Re: Request for Spirit and Intent Letter
4311 Old Milford Mill Road, Baltimore, MD

PLAN TO ACCOMPANY
SPIRIT AND INTENT LETTER
4311 OLD MILFORD MILL ROAD

RE: 4311 Milford Mill Road
Zoning Case #89-527-A
3rd Election District

Re: Milford Mill Site
Shore Communications
Project No. 96011

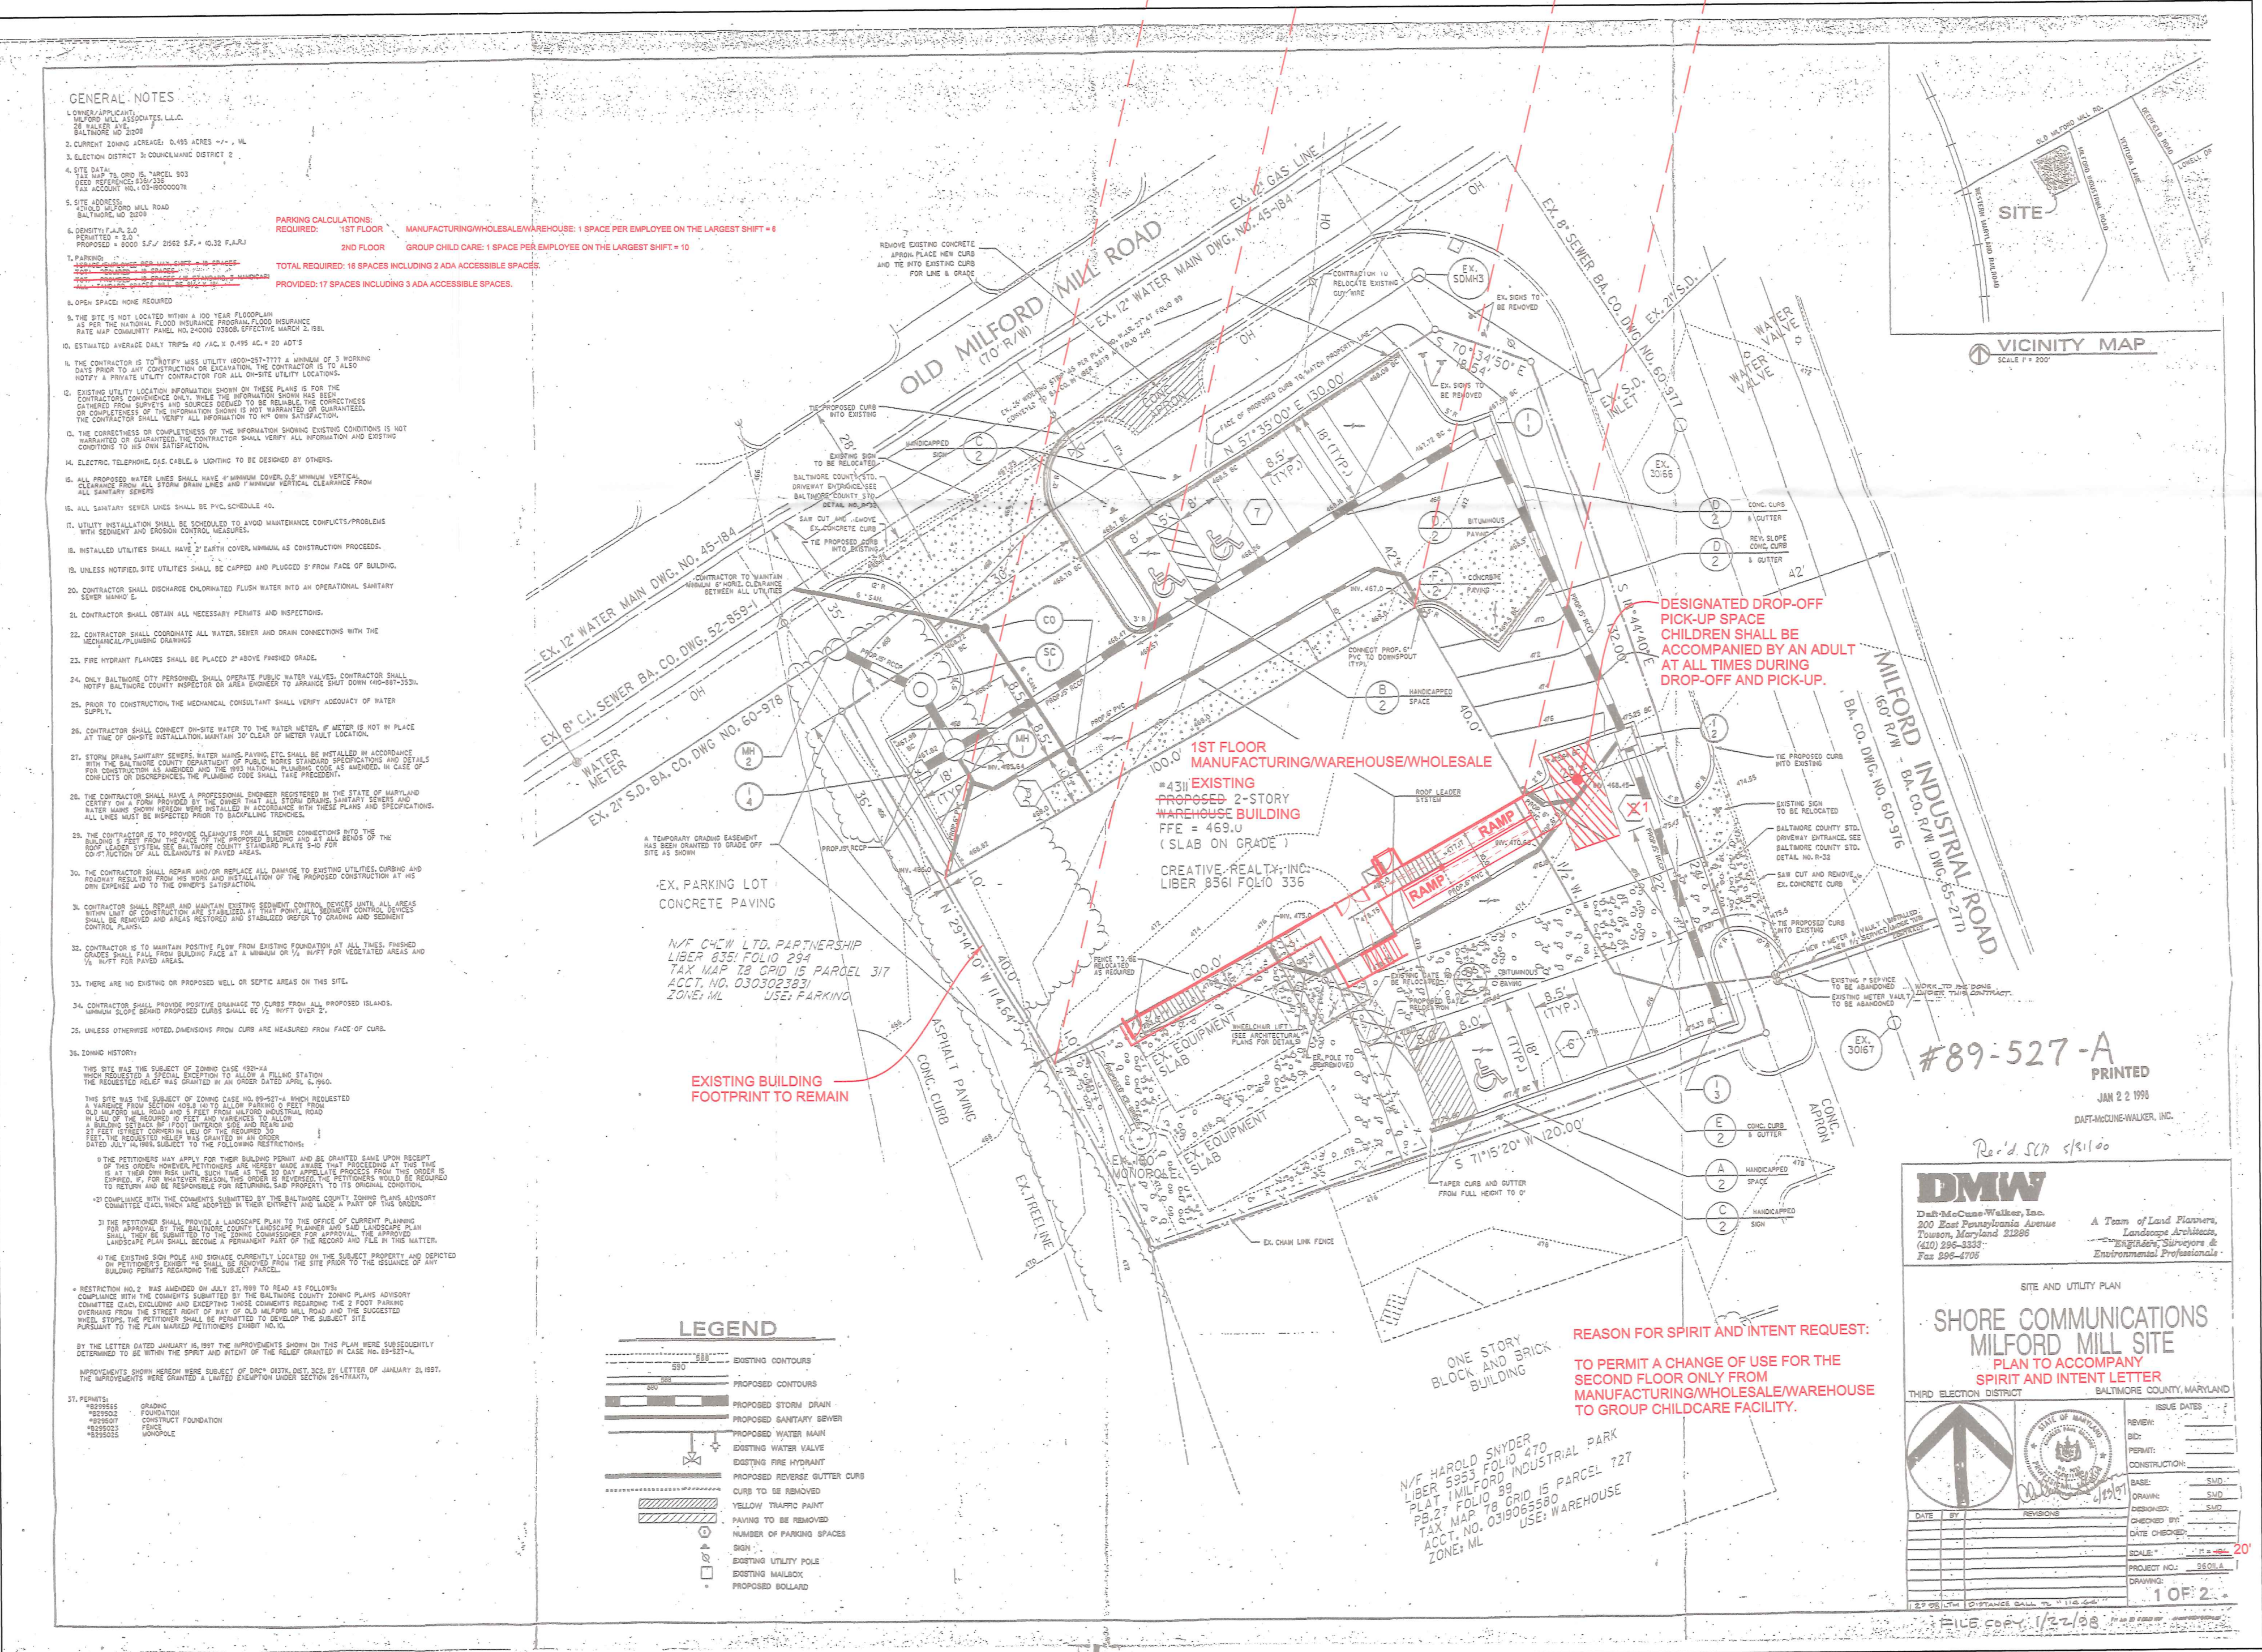
I have enclosed a redline of the most current site plan used in Case No. 89-527-A entitled "Plan to Accompany Spirit and Intent Letter", which shows the previously approved site plan and the proposed improvements shown in red.

REASON FOR SPIRIT AND INTENT REQUEST:
TO PERMIT A CHANGE OF USE FOR THE SECOND FLOOR ONLY FROM MANUFACTURING/WHOLESALE/WAREHOUSE TO GROUP CHILDCARE FACILITY.

If you are in agreement kindly countersign this letter confirming that the proposed uses and parking counts are within the spirit and intent of the relief granted in Case No. 89-527-A.

SITE AND UTILITY PLAN

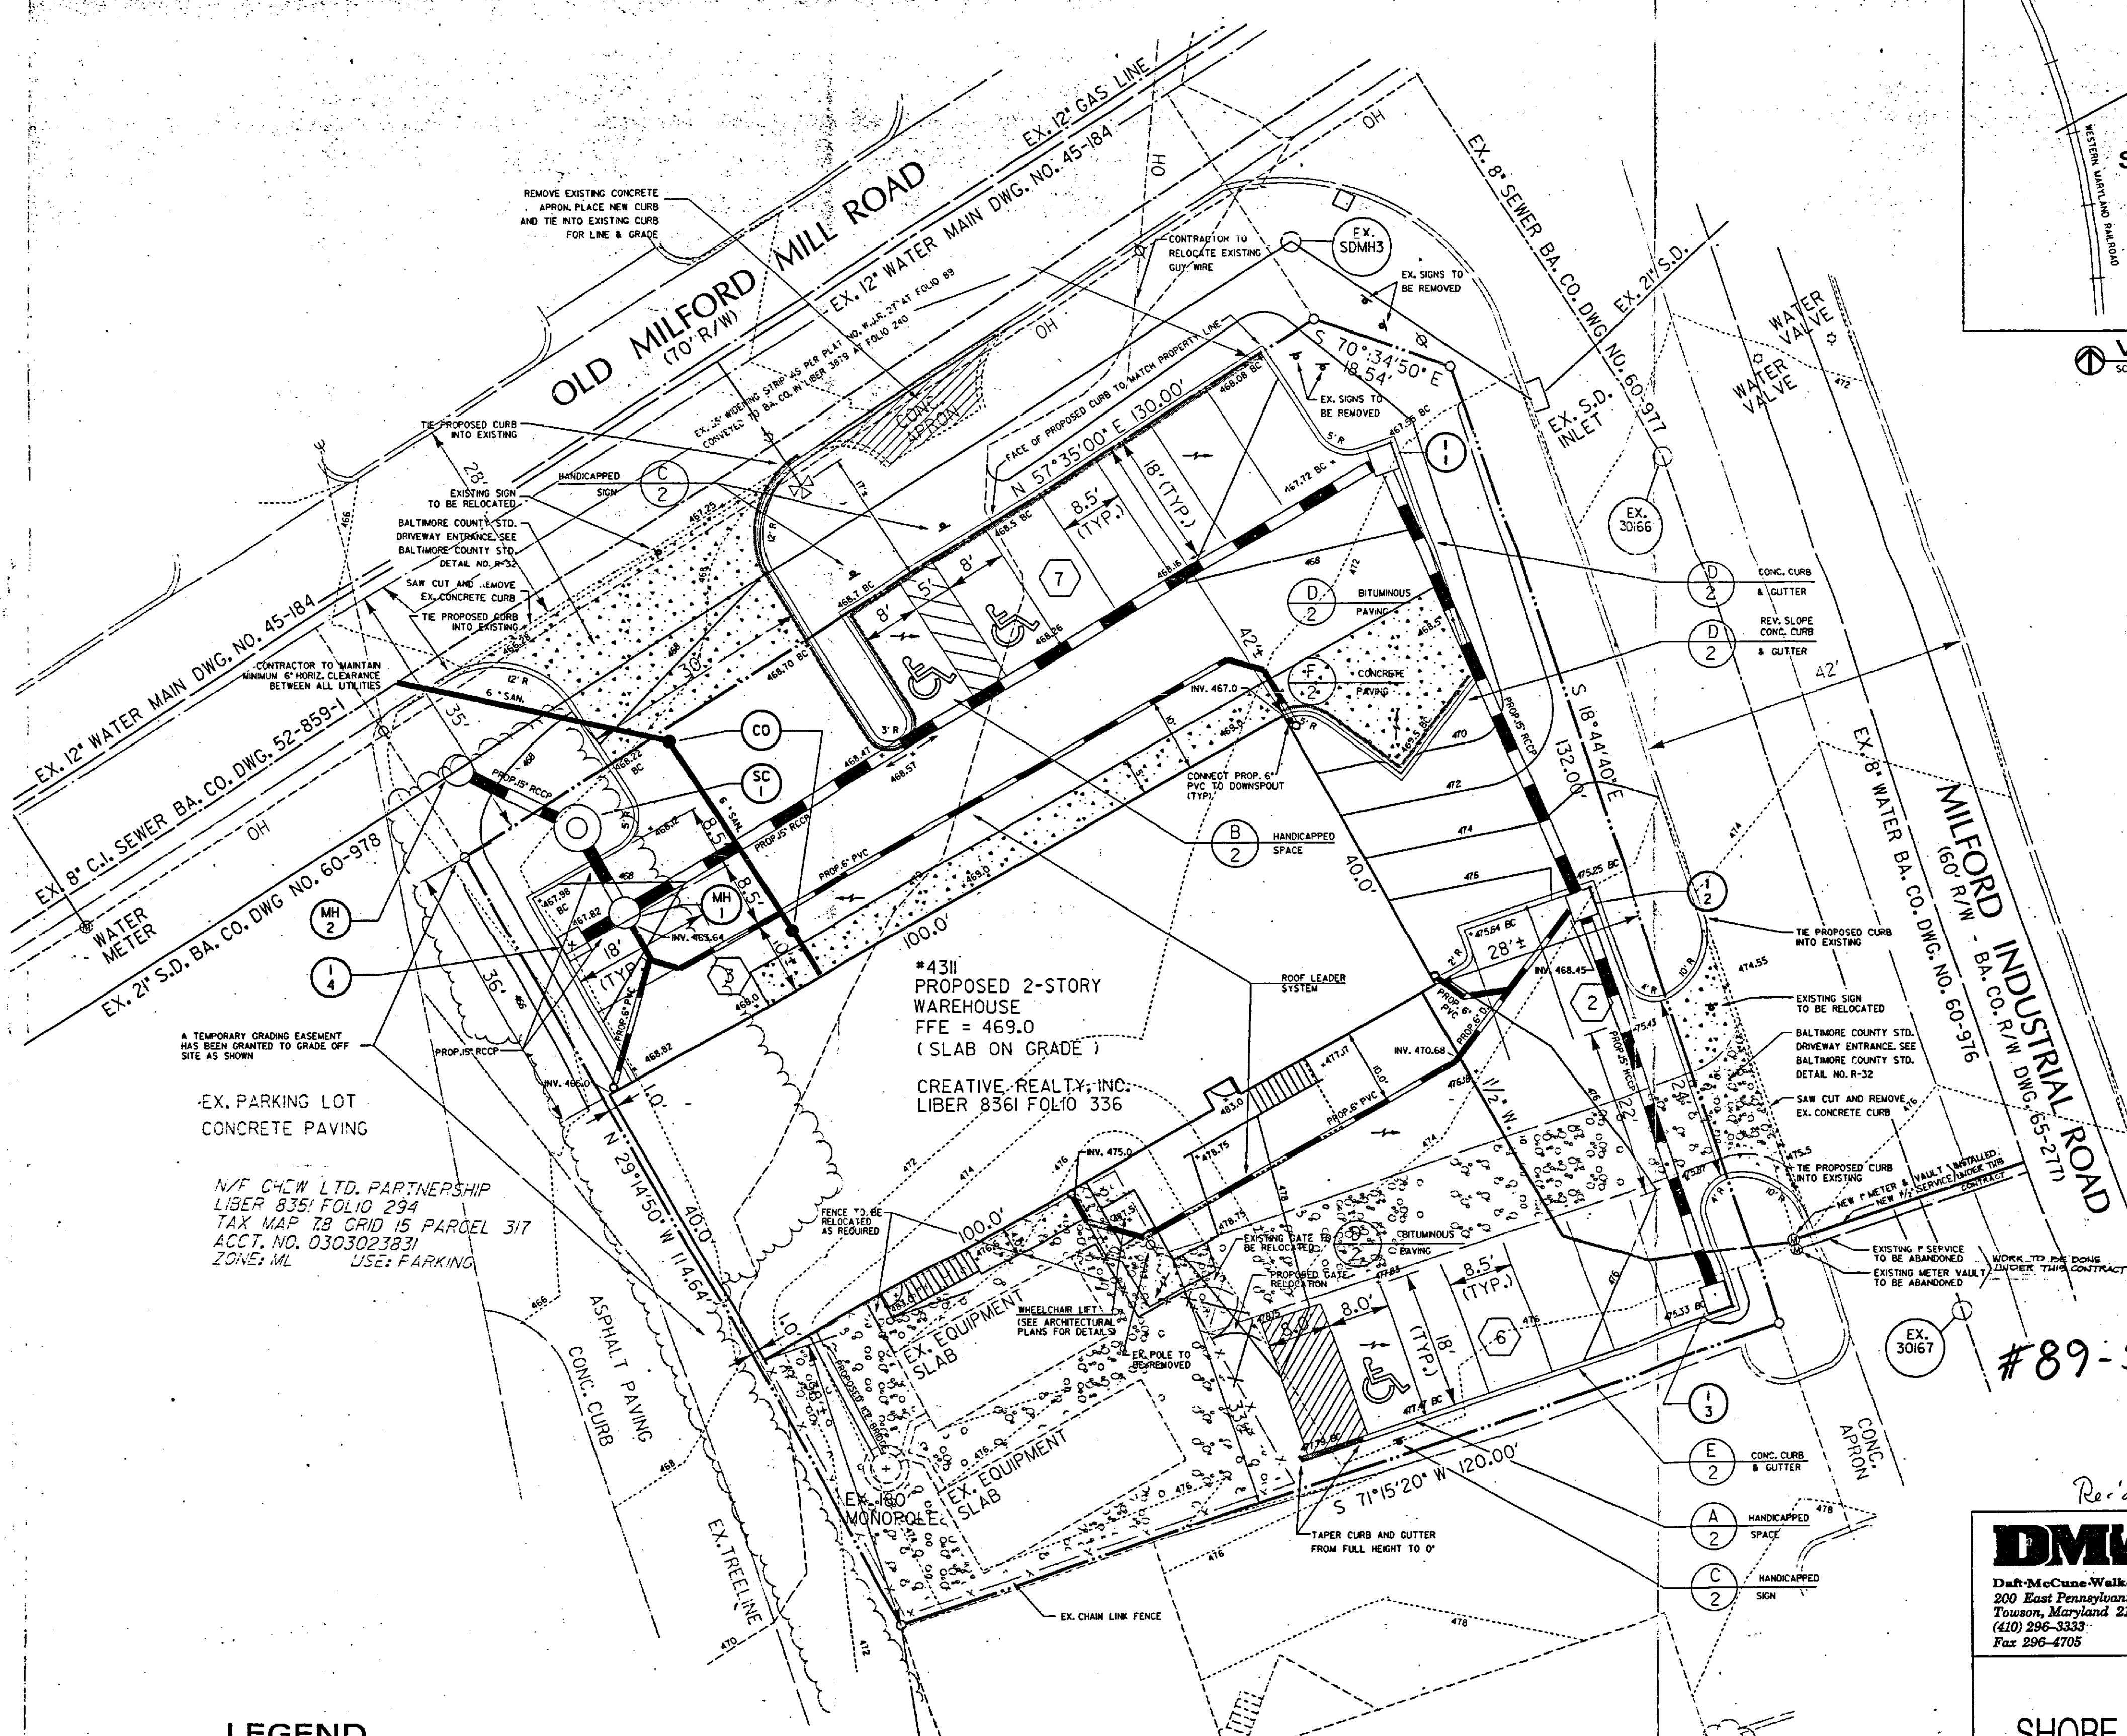
Enclosed are two prints of a marked up site plan, the original of which accompanied the Variance petition in Zoning Case 89-527-A. The petition sought a variance to allow parking within zero feet of Old Millford Mill Road and within five feet of Milford Industrial Road in lieu of the required ten feet as well as variances to permit building setbacks of one foot for the interior side and rear yards and twenty-seven feet for a street side yard in lieu of the required thirty yards. There was no opposition at the hearing, and the requested relief was granted in an Order dated July 14, 1999, subject to several minor restrictions.

The current plan for the site represents a minor departure from the approved zoning site plan insofar as the overall warehouse has been reduced in size to make room for the proposed wireless transmitting and receiving facility. As the parking arrangement remains essentially the same and all of the setbacks for which variances were previously granted will remain as approved or will be more generous, we believe that the revised plan falls within the spirit and intent of the originally granted relief.

Per our first conversation, I stated that the proposed buildings on shown on the prior submitted site plan, which accompanied your December 24, 1996 letter, would not be approved as being within the spirit and intent of the granted zoning hearing case #09-527-A. Per our second conversation, your letter dated January 8, 1997, and the accompanying site plan showing a detail of the structural and functional connections, this office will approve this request as being within the spirit and intent of the aforementioned zoning case.
